Re: May 2020 Central Valley Ag Group (CVAG) Bulk Whole Cottonseed Transload Facility Initial Study/Mitigated Negative Declaration for the CVAG Bulk Whole Cottonseed Transload Facility at the Port of Stockton

The Delta-Sierra Group (DSG) has completed review of the Initial Study/Mitigated Negative Declaration (IS/MND) to address the environmental effects of developing the Central Valley Ag Group rail-to-truck transload facility for whole cottonseed at property owned by the Port of Stockton, shown in the photo below. The IS/MND is deficient in a number of areas such as the characterization of whole cottonseed, air quality, greenhouse gas emissions-energy, and stormwater which the California Environmental Quality Act (CEQA) requires that an environmental impact report (EIR) be prepared instead of a mitigated negative declaration. Delta-Sierra Group's review indicate that additional environmental analyses and mitigations are necessary to comply with local, regional, and state regulatory guidance related to the facility's operational activities.

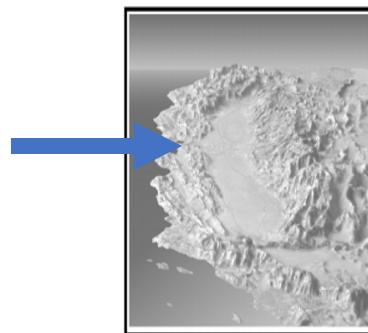
The IS/MND described the prevailing winds in Stockton as: “winds are predominately up-valley (from the north) in all seasons, but more so in the summer and spring months.” This may be true of the southern part of the San Joaquin Valley but not so for Stockton CA, where prevailing winds are more westerly (from the west to the east). The direction of the wind becomes important when assessing the population exposure.

Data that conflicts with the description of prevailing winds has been obtained from two sources: Western Regional Climate Center<sup>6</sup> and the California Air Resources Board (CARB) air quality monitoring station located at Public Health Services on Hazelton Avenue in Stockton CA. The data from Western Regional Climate Center includes prevailing wind direction based on the hourly data from 1992-2002 obtained from the Stockton Municipal Airport (KSCK) and is defined as the direction with the highest percent of frequency.
